Model : GP605

Ref. No. : FF-T01-K1-000009-UK2

Location : SLIDE GUIDE (ON THE ADF PICKUP TRAY)

Subject : PREVENTING JAMS WHILE READING AN ORIGINAL

Fig. 1

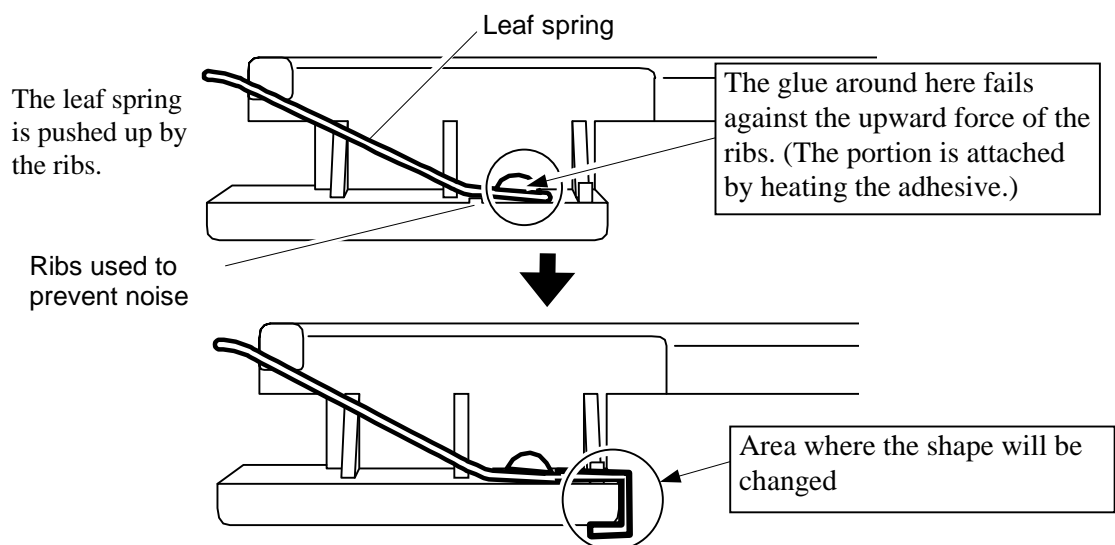
A portion of the leaf spring of the slide guide (rear) found on the ADF pickup tray can fail against the upward force of the ribs found under the spring, resulting in detachment.

The ribs of the slide guide (used to prevent noise; see the figures below) are shaved off to limit the stress against the glued portion (switch-over on and after March 30, 1999).

In addition to the tentative measures above, the shape of the leaf spring will be modified to prevent stress on the leaf spring (see the figures below; switch-over on and after April 13, 1999).
